RGA No. 22008
March 2, 2023

ADDENDUM NO. 1

**LAKE FOREST SCHOOL DISTRICT -
Delaware Early Childhood Center – HVAC Upgrades**
100 W. Mispillion St., Harrington, DE 19952

1 PARTIAL FLOOR PLAN - NEW WORK - ELECTRICAL
SCALE : 1/8" = 1'-0"

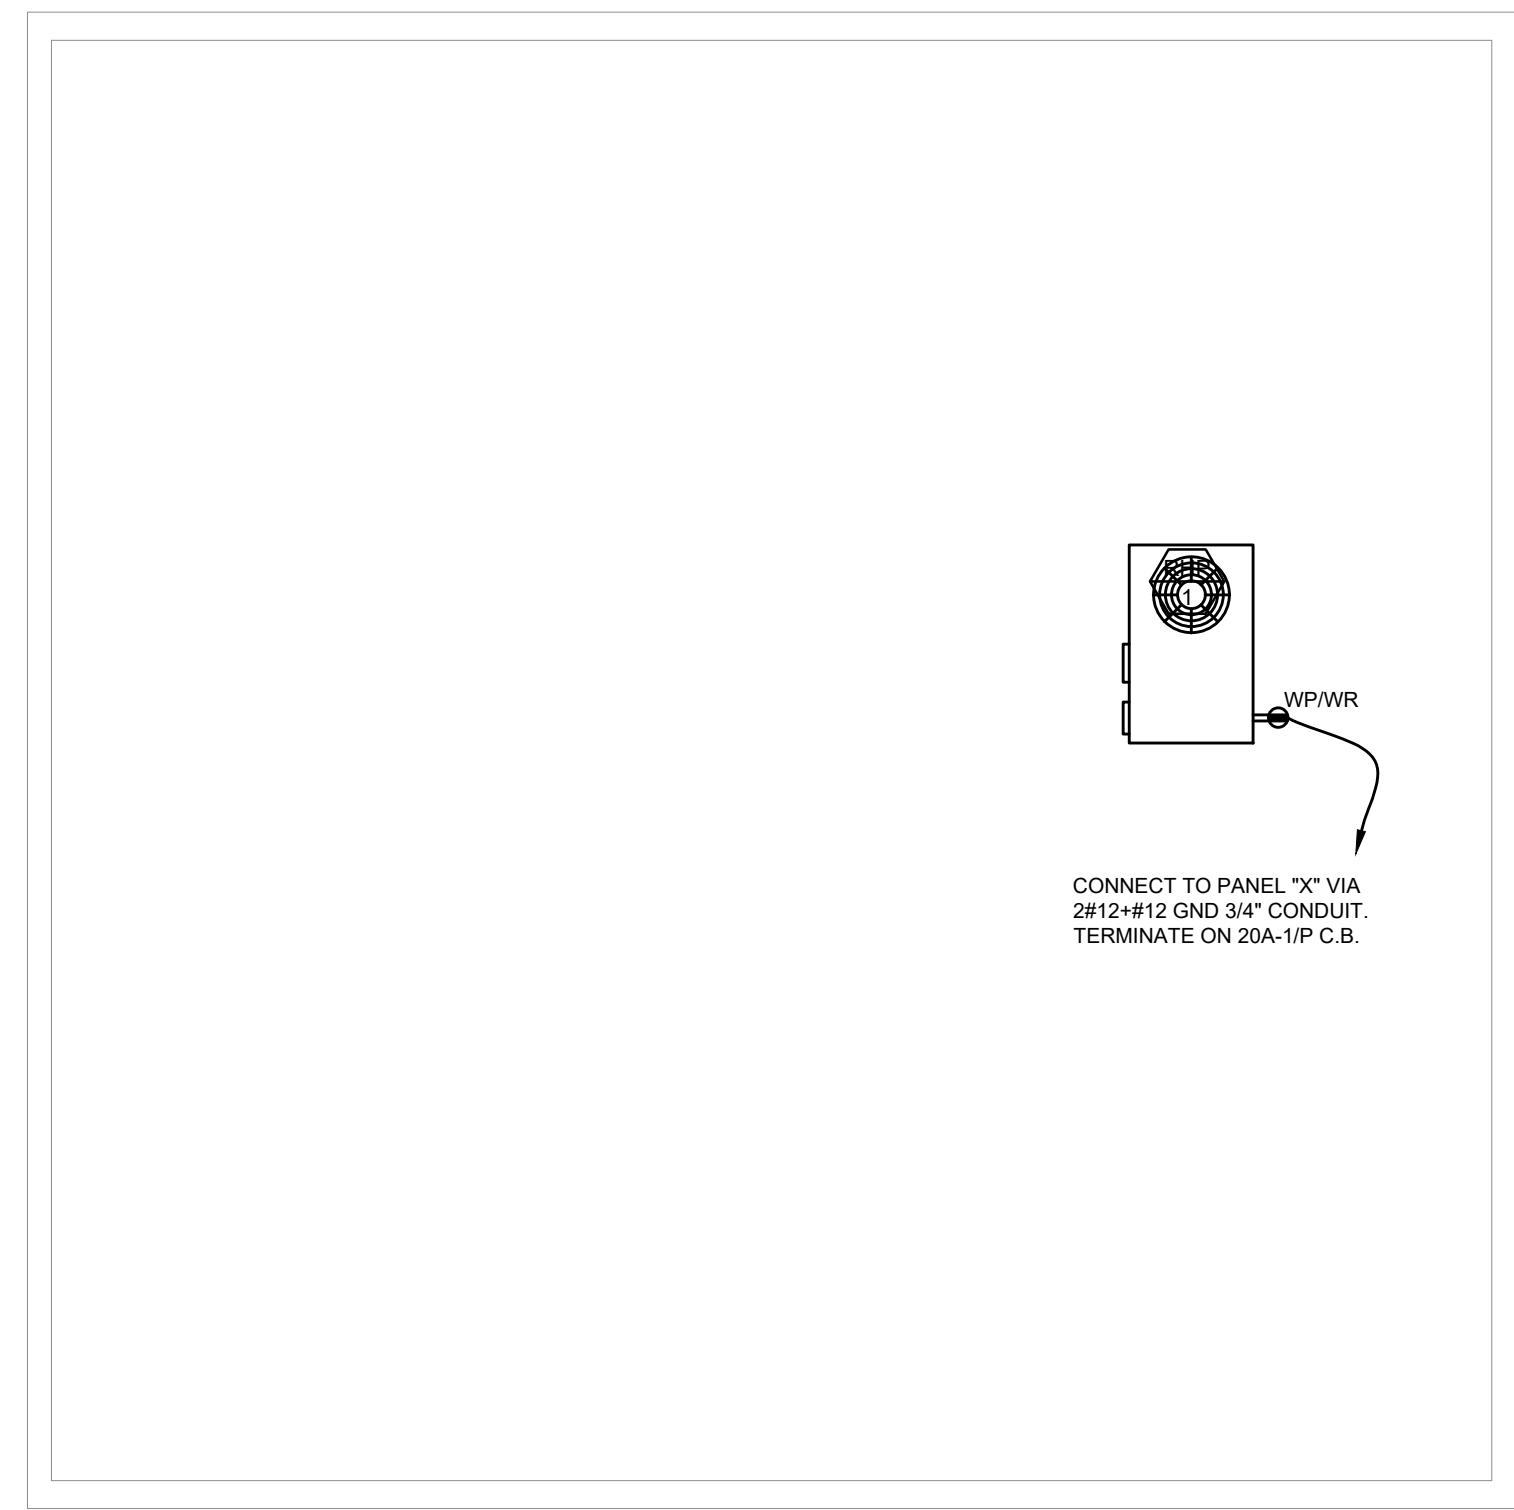
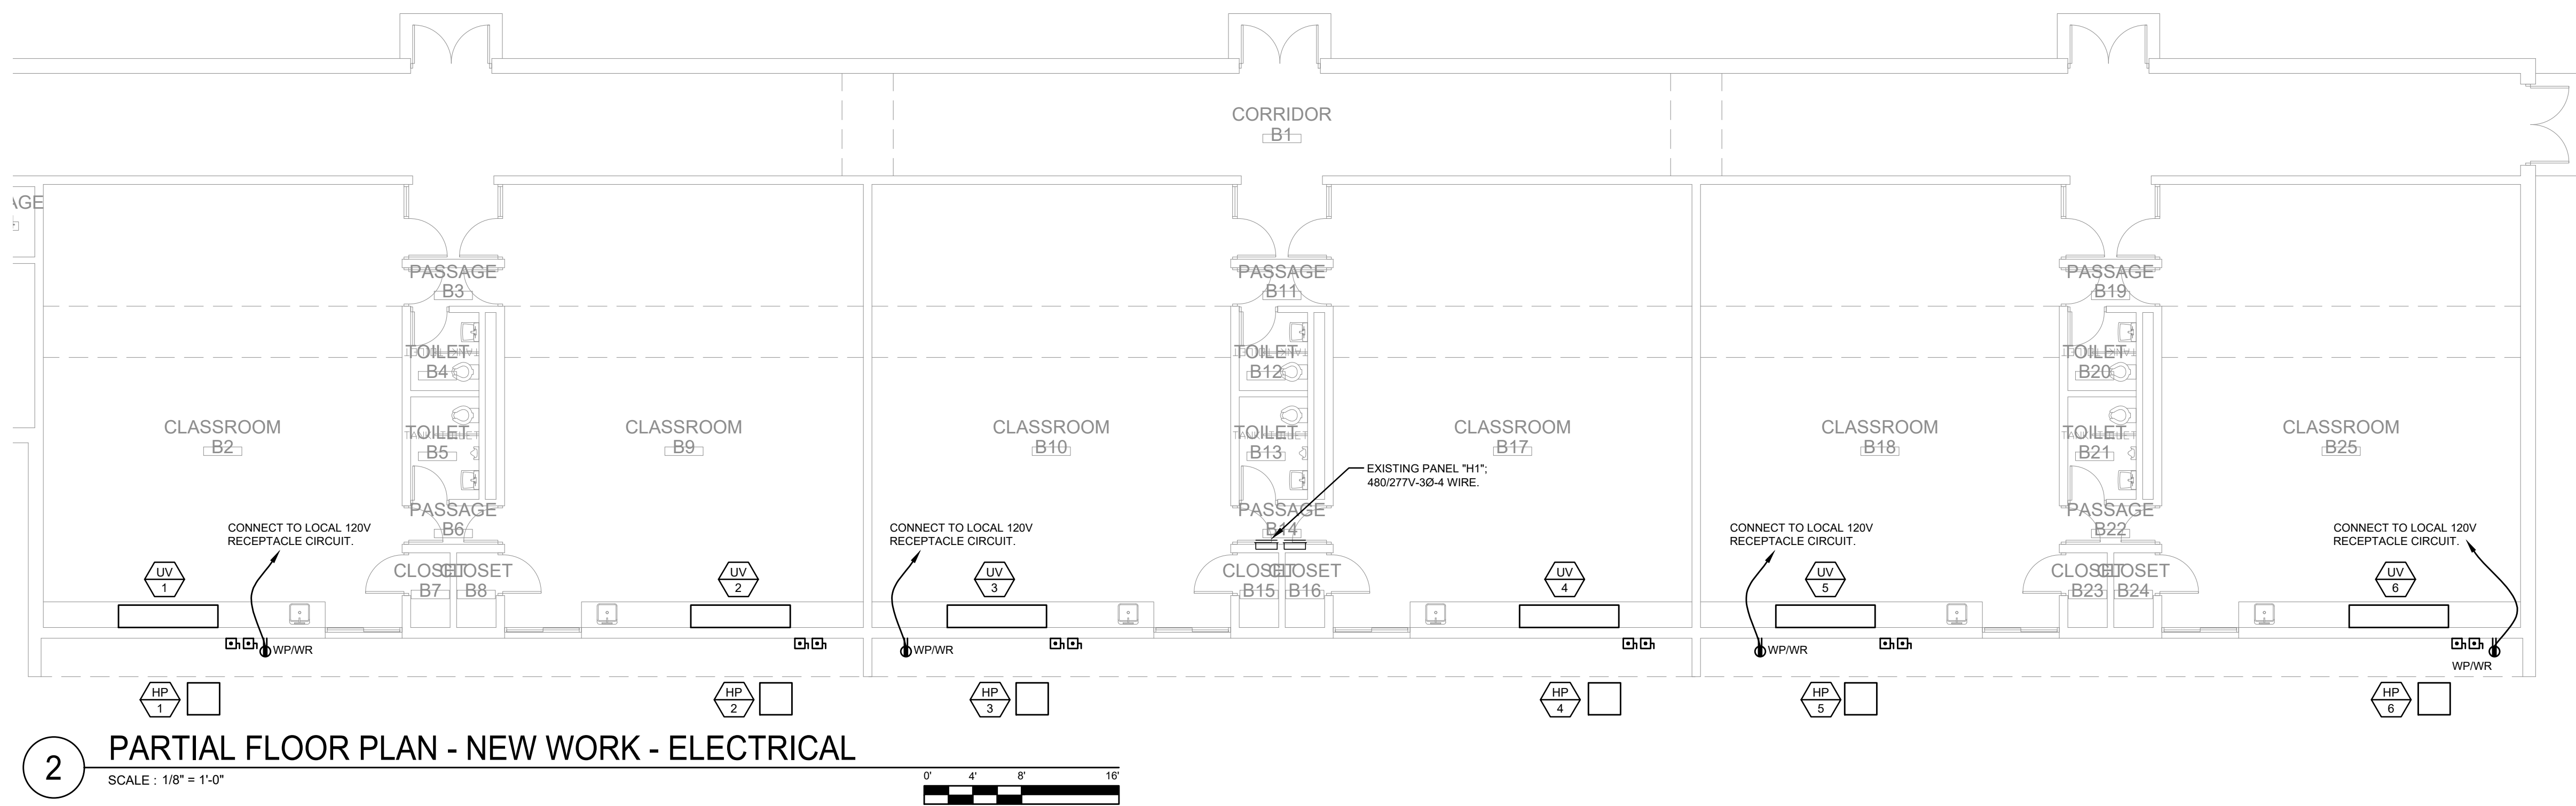
- 4.1 Drawing ED-1, “FLOOR PLANS DEMOLITION ELECTRICAL”
4.1.1 REMOVE Existing lighting shown in room A12. See revised drawing ED-1.
4.2 Drawing E10-1, “FLOOR PLANS NEW WORK ELECTRICAL”
4.2.1 REMOVE New lighting shown in room A12. See revised drawing E10-1.
